For Discussion – NYSRC ULFS Requirement

The NYSRC Reliability Rules and Compliance Manual (“RR&CM”) carries a provision under section D.2 *Underfrequency Load Shedding* requirement R1 *Load Shedding Allocation* that is not clear (vague) and may not be aligned with NPCC Directory 12 and NERC PRC-006-NPCC. The provision is the 3rd paragraph of R1 *Load Shedding Allocation*:

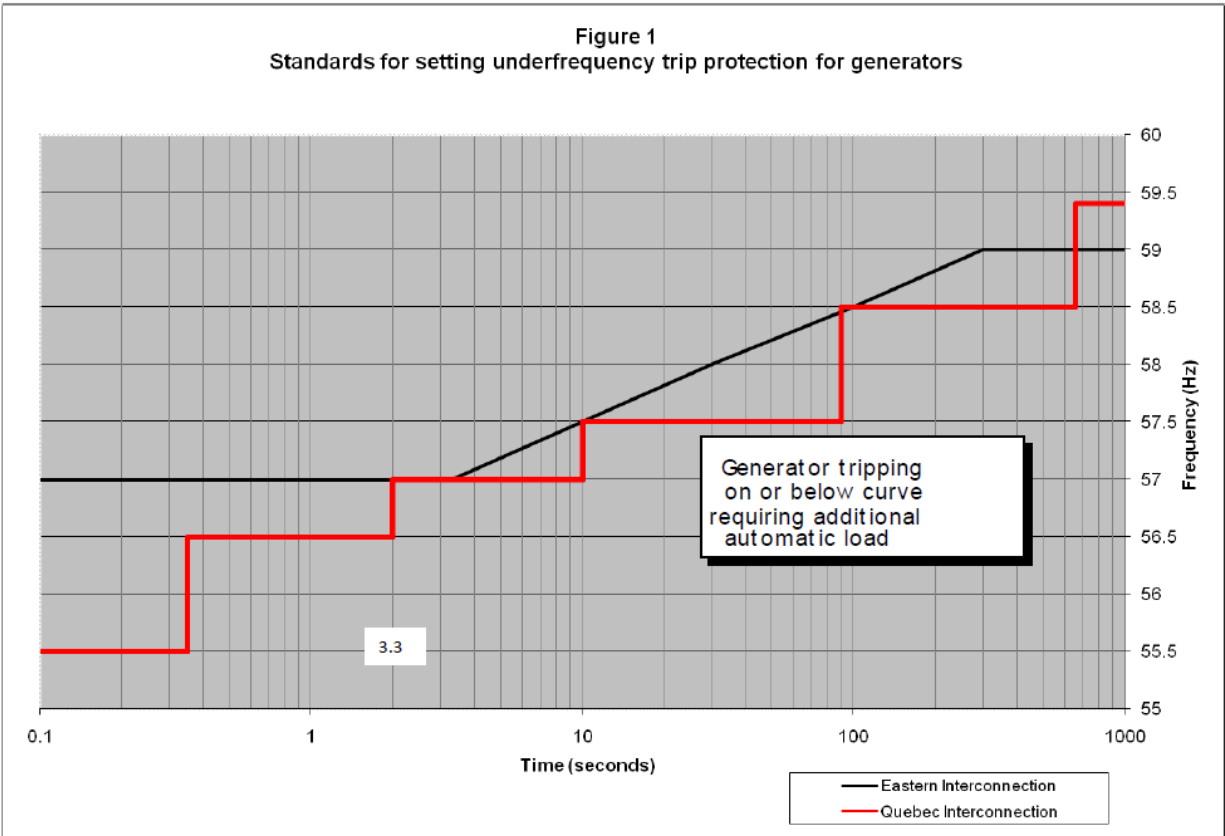
- 1) Does NYSRC D.2 requirement R1 align with the philosophy of NPCC Directory 12 and NERC PRC-006-NPCC?
- 2) Does the 3rd paragraph of RR&CM D.2 requirement R1 violate the requirements established in NPCC Directory 12 and NERC PRC-006-NPCC that require: “[...] generators shall not be tripped for under-frequency conditions in the area above the curve in Figure 1 [...]” (NPCC Directory 12 R5.4 / NERC PRC-006-NPCC R13)?

- 3) Is 58.5 Hz a valid threshold? As NPCC Directory 12 Figure 1 and NERC PC-006-NPCC-1 Figure 1 allow a floor frequency of 57 Hz for setting under-frequency trip protection for generators. In addition, NPCC Directory 2 Requirement 6.1 (see Q2) refers to Figure 1 as the trigger point for generation isolation.

Generators shall not be tripped for under-frequency conditions in the area above the curve in Figure 1, except as provided for in Sections 5.4.1 and 5.4.2.
